Access Compliance Report

Public Rights-of-Way

(Curb Ramps)

Intersection ID: 3029	Main Street: AMBER_GLEN_DR	Cross Street: GARNET_FIELD_CT	Location: NE
ADA ID: 0EFB0C5241D3	Ramp Type: Perp	Initial Pass/Fail: Fail	Overall Compliance: No
		Severity Score: 10

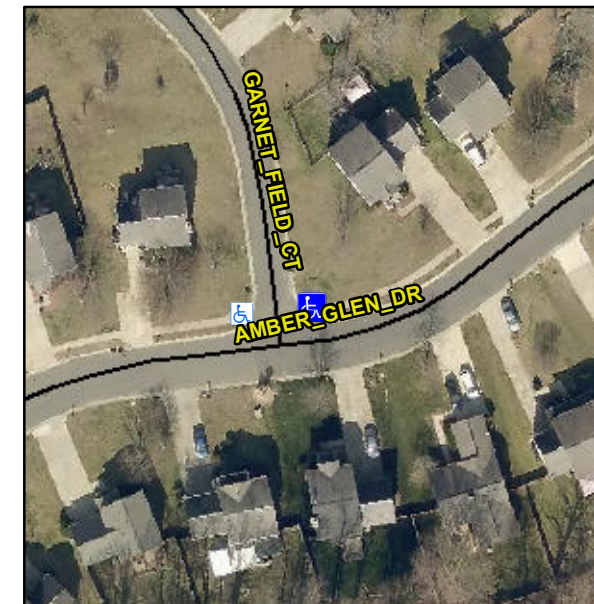
Not Found, R304.5.1, R304.5.3

Compliance	Description	Data	Compliance	Description	Data
N/A	Ramp Length (in)	48.0	Yes	Ramp Slope (%)	7.2
No	Ramp Width (in)	46.0	No	Ramp XSlope (%)	3.3
N/A	Flare Type LT	N/A	N/A	Flare Type RT	N/A
N/A	Flare Slope LT (%)	N/A	N/A	Flare Slope RT (%)	N/A
N/A	Flare Traversable LT?	N/A	N/A	Flare Traversable RT?	N/A
N/A	Landing Length (in)	N/A	N/A	DWS Provided?	N/A
N/A	Landing Width (in)	N/A	N/A	DWS Contrast?	N/A
N/A	Landing Slope (%)	N/A	N/A	DWS Length (in)	N/A
N/A	Landing X Slope (%)	N/A	N/A	DWS Full Width?	N/A
N/A	Landing Curb? (Y/N)	N/A	N/A	DWS Offset (in)	N/A
N/A	Shared Landing?	N/A			
N/A	Gutter Ponding?	N/A	N/A	Gutter Slope (%)	N/A
N/A	Gutter Lip Ht (in)	N/A	N/A	Gutter X Slope (%)	N/A
N/A	Painted X Walk1?	No	N/A	Painted X Walk2?	N/A
	X Walk 1 Direction	To W		X Walk 2 Direction	N/A
N/A	X Walk 1 Width (in)	N/A	N/A	X Walk 2 Width (in)	N/A
	X Walk 1 Slope (%)	2.7		X Walk 2 Slope (%)	N/A
	X Walk 1 X Slope (%)	1.9		X Walk 2 X Slope (%)	N/A

Remove & Replace Entire Ramp.
